SUBJECT: FLOW DEPENDENT MINIMUM CRITICAL POWER RATIO (MCPR), SUSQUEHANNA  
STEAM ELECTRIC STATION, UNIT 1 (TAC NO. M83360)

Amendment No. 122  
License No. NPF-14

ATTACHMENT TO LICENSE AMENDMENT NO. 122

SAFETY EVALUATION BY THE OFFICE OF NUCLEAR REACTOR REGULATION  
RELATED TO AMENDMENT NO.122TO FACILITY OPERATING LICENSE NO. NPF-14

**FLOW DEPENDENT MCPR OPERATING LIMIT**  
**FIGURE 3.2.3-1**

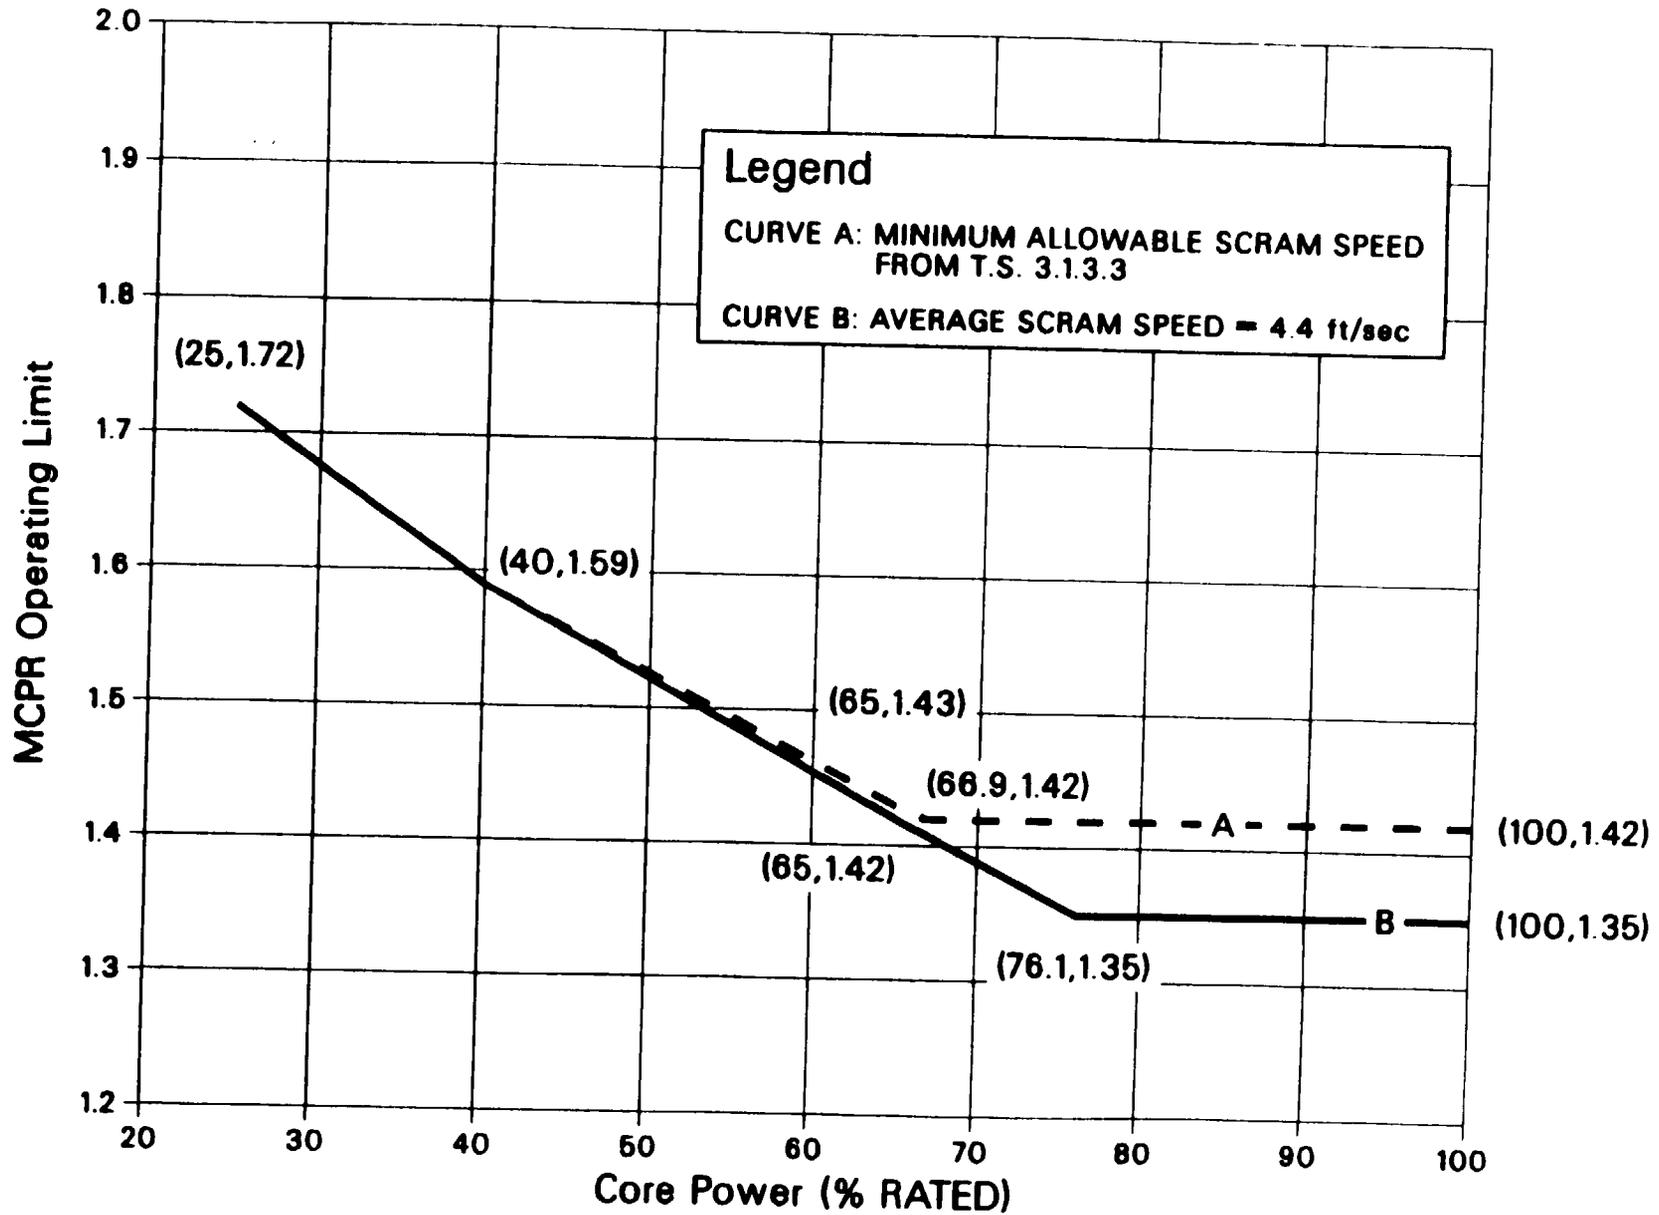
After issuance of Amendment 118, the licensee discovered an error in the calculation of the Unit 1 Technical Specifications flow-dependent MCPR operating limit curve. The corrected MCPR Operating Limits were entered into the licensee's Powerplex core monitoring system on May 15, 1992 under administrative control and staff agreement. The licensee is currently operating under these corrected limits and is making this change to the Technical Specifications to make the corrections to the calculational error permanent.

The single calculational error affected TS Figure 3.2.3-1. The corrected Figure 3.2.3-1 is consistent with the proper implementation of the licensee's NRC-approved licensing methods in support of Unit 1 Cycle 7 operations. The new curve presented in Figure 3.2.3-1 is more restrictive over the entire range where the recirculation flow controller failure event transient is limiting.

The staff finds this change to be acceptable. The corrected Figure 3.2.3-1 will ensure reactor operation within its design basis and preserves the validity of the Unit 1 Cycle 7 reload safety analysis.
